**FINAL REPORT
VALUE ENGINEERING STUDY**

CDOT REGION 6

**I-225/Mississippi to Parker Road
Widening Project
Including RTD's Iliff Extension**

February 2011

Phase 1 Crossover

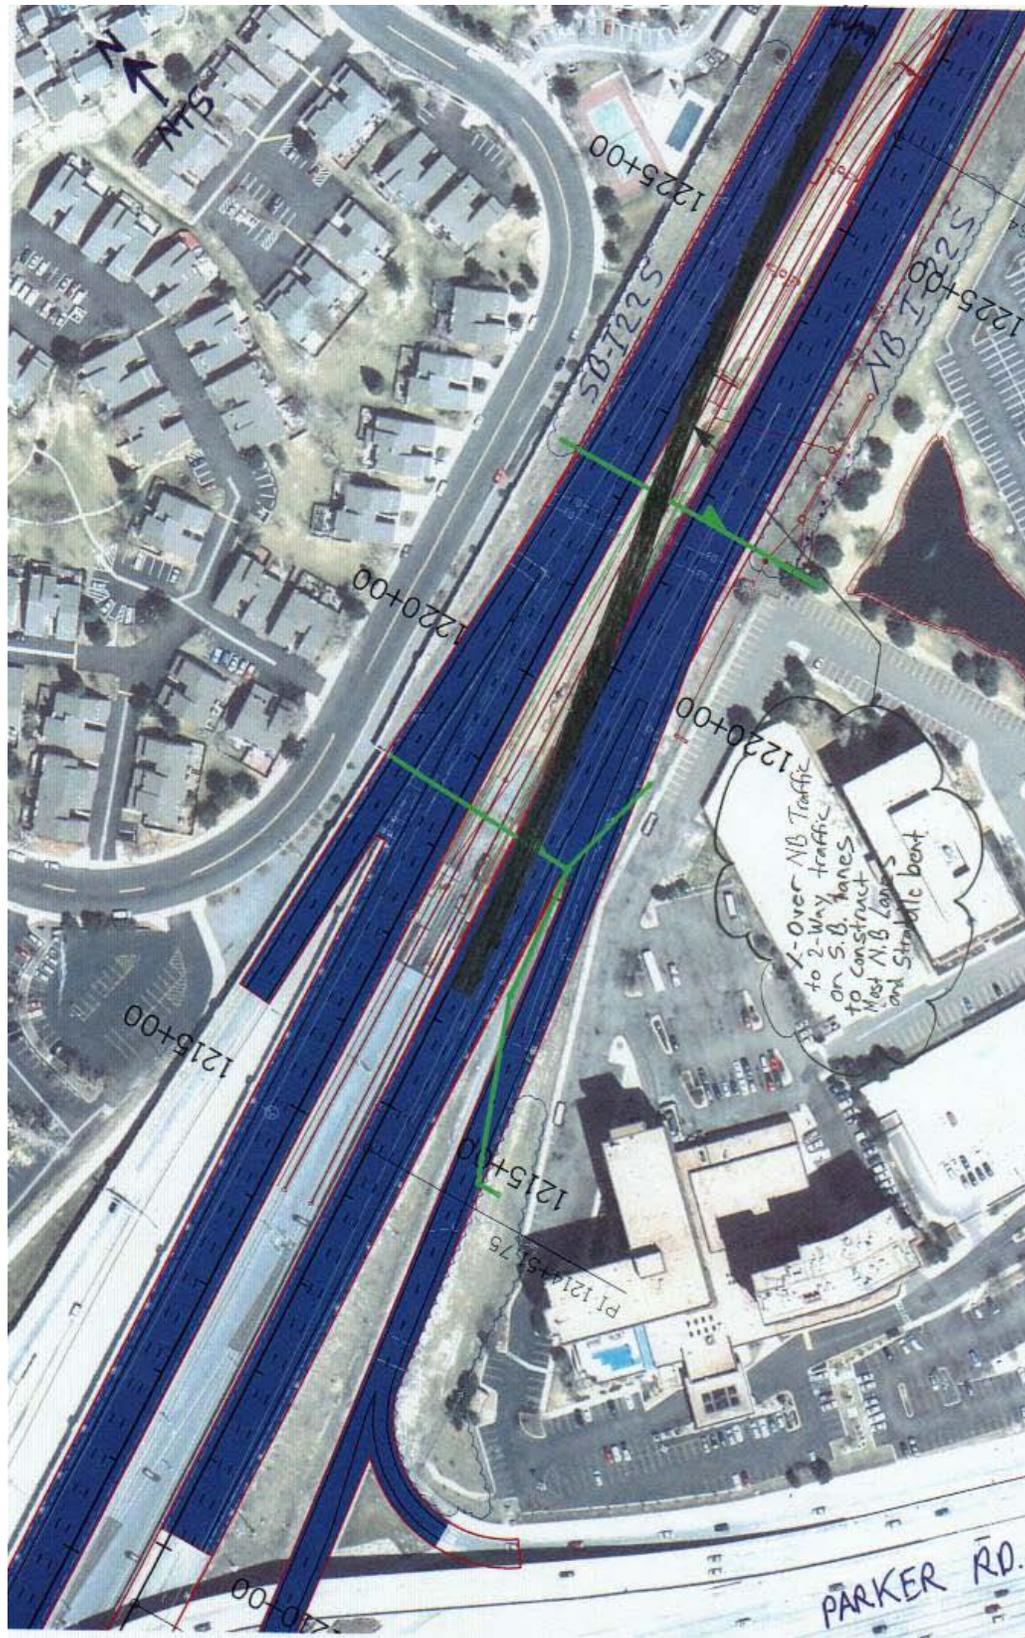
1. Cross over just north of where existing light rail facility ends near the Parker interchange may not be geometrically possible before conflicting with straddle bents.

After producing a rough hand sketch, it appears that a crossover that realigns north bound traffic head to head with south bound traffic is geometrically feasible. This crossover would occur south of where the two straddle bents are to be constructed. This will allow the straddle bents to be constructed along with the majority of the northbound I-225 lanes while traffic is on the southbound lanes. Further analysis is required to ensure the crossover will fit in after the end of the light rail and before the straddle bents.

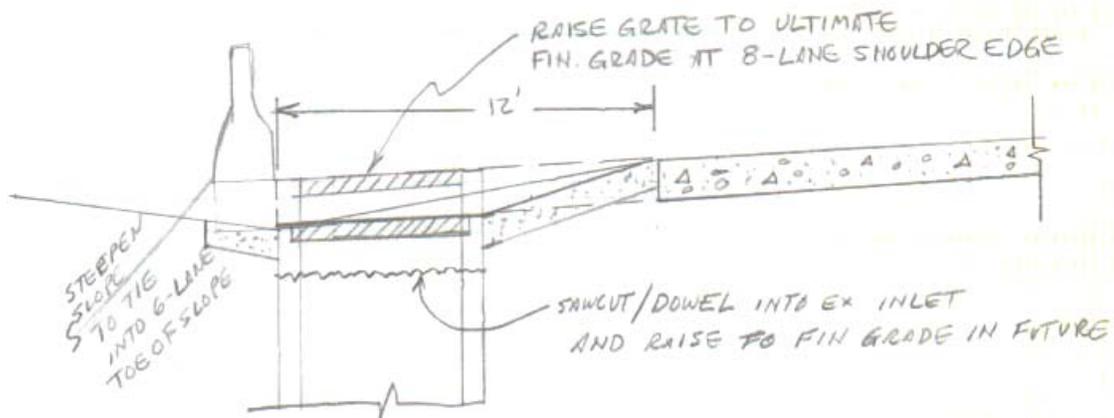
The proposal is to strategically locate drainage inlets at the ultimate location for the inlets for the 8-lane construction. This proposal would save removing and reconstructing inlets along the project length by strategically placing the inlets in locations that facilitate using them for both the 6-lane configuration as well as the ultimate 8-lane configuration.

This proposal requires a complete design for the interim as well as the ultimate to determine actual locations to construct these inlets. The status of the plans to-date show utilizing ditches to convey runoff along the east side of the project.

Phase 3 – Stage 1 Construction

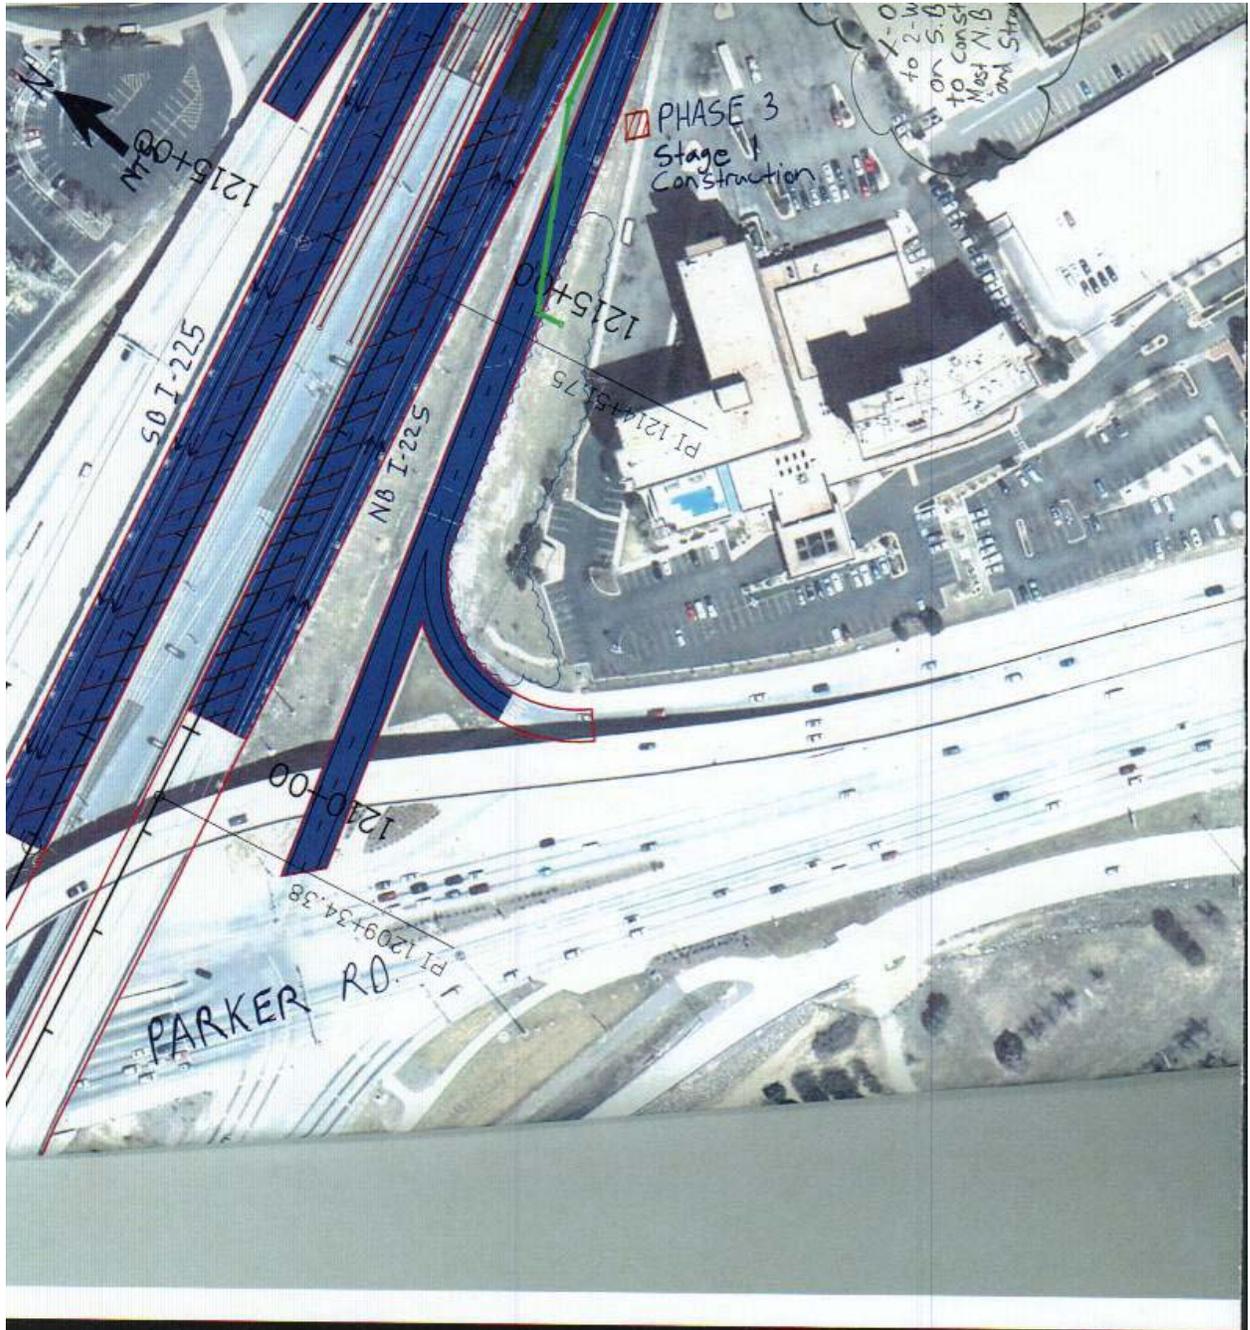
Stage 1: Maintain traffic on the outside northbound and southbound pavement while two lanes and the median shoulder are being constructed for both northbound and southbound. Construct the remaining south portion of the light rail previously in conflict with the south crossover in the median area.

Stage 2: Maintain traffic on the inside northbound and southbound pavement while the third lane and shoulder are being constructed for both northbound and southbound.
